CORPORATION OF THE TOWNSHIP OF ESQUIMALT

File #: 21-560 **Version:** 1 **Name:**
Type: Staff Report **Status:** Passed
File created: 11/8/2021 **In control:** Advisory Planning Commission
On agenda: 11/16/2021 **Final action:** 11/16/2021
Title: Development Variance Permit Application – 856 and 858 Esquimalt Road
Staff Report No.: APC-21-023

Report No. APC-21-023

Development Variance Permit Application - 856 and 858 Esquimalt Road [PID 002-925-966; Lot 2, Section 11, Esquimalt District, Plan 23904 and PID 026-691-418; Lot A, Section 11, Esquimalt District, Plan VIP80973]

Figure 1.

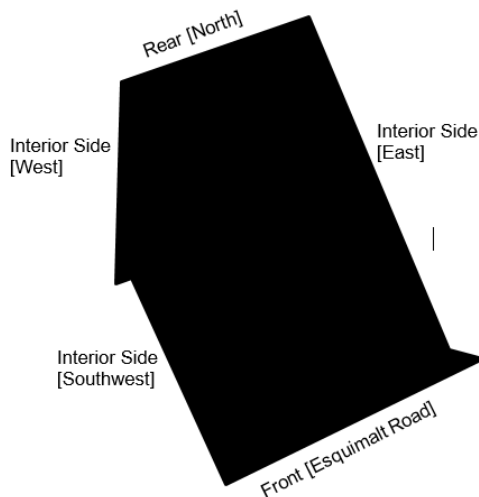
(8) Siting Requirements

Within this CD-80 Zone, lot lines and setbacks shall be determined in accordance with Figure 1 (below).

- (i) No Building shall be located within 7.1 metres of the Front [Esquimalt Road] Lot Line.
- (ii) The northwest wing of the southern Principal Building [Building A] shall not be located within 4.3 metres of the Interior Side [West] Lot Line.

- (iii) The southwest corner of the southern Principal Building [Building A] shall not be located within 3.1 metres of the Interior Side [Southwest] Lot Line.

- (iv) The western wing of the southern Principal Building [Building A] shall not be located within 11.9 metres of the Interior Side [East] Lot Line.
- (v) No Building shall be located within 7.5 metres of the Rear [North] Lot Line.

- (vi) The northern Principal Building [Building B] shall not be located within 7.7 metres of the Interior Side [East] Lot Line.
- (vii) The northern Principal Building [Building B] shall not be located within 6.4 metres of the Interior Side [West] Lot Line.

- (viii) The separation between the east wing of the southern Principal Building [Building A] and the south wing of the northern Principal Building [Building B] shall not be less than 17.6 metres.

- (ix) The separation between the northwest wing of the southern Principal Building [Building A] and the west wing of the northern Principal Building [Building B] shall not be less than 12.5 metres.
- (x) The separation between the northwestern wing of the southern Principal Building [Building A] and the south wing of the northern Principal Building [Building B] shall not be less than 20.0 metres.
